## **Stage 1/2 Road Safety Audit**

**Housing Development at Pairc na hAbhainn, Athenry**

**On behalf of Galway County Council**

**November 2025**

#### 4.1.1 Entrance to proposed development

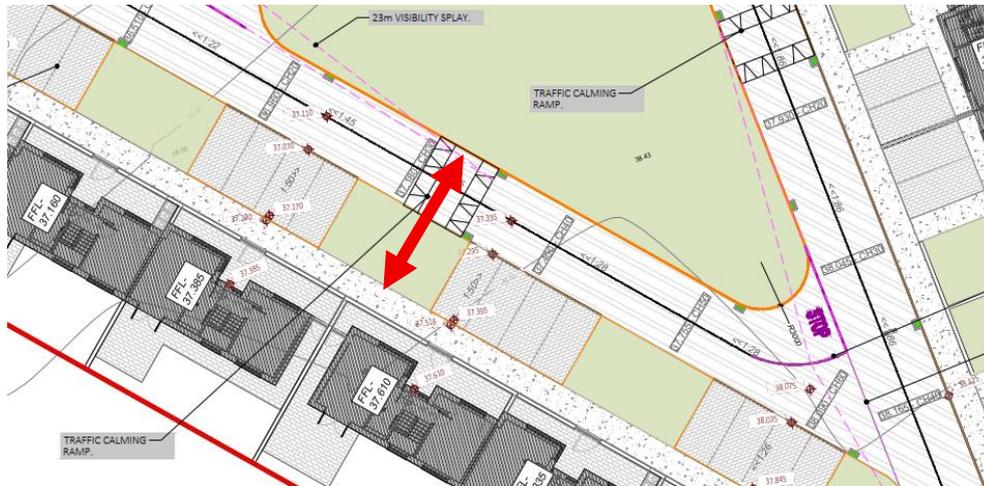
**Problem:** The entrance to the proposed housing development is confusing, whereby the priority is offered to motorists who are undertaking a sharp right-hand turn. It is likely users exiting from the eastern road will not stop at the indicated road junction.

**Hazard:** Impacts within the junction may result.

**Recommendation:** The Design Team should redesign the junction such that the use is intuitive.

### 4.2.2 Existing Turning Head / Footpath Connectivity

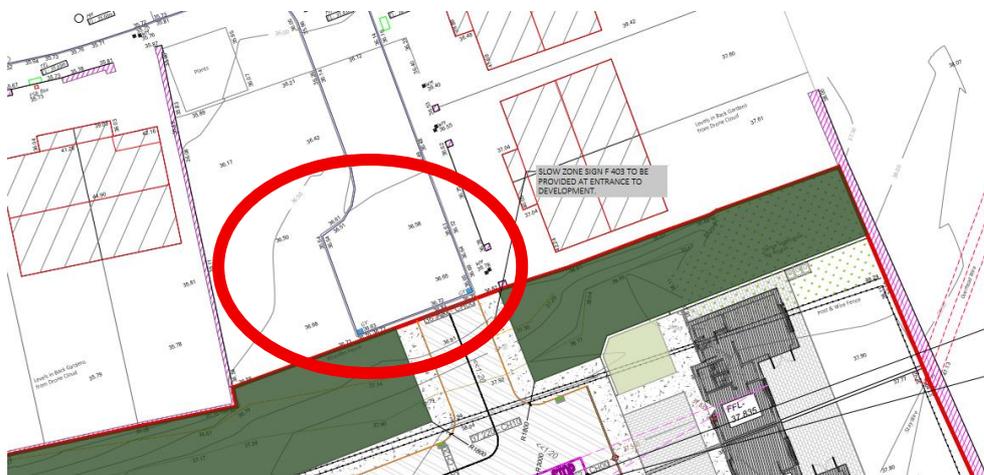
**Problem:** The proposed development extends where the existing turning head is located. There is no footpath to the western side of the existing estate road for the proposed new footpath to connect with. Pedestrians exiting the proposed development are likely to cross the road diagonally, with their back to development exiting traffic in this area.

**Hazard:** Pedestrians may be struck by vehicles.

**Recommendation:** The Design Team should interconnect the footpaths to the southern side of the existing housing development road.
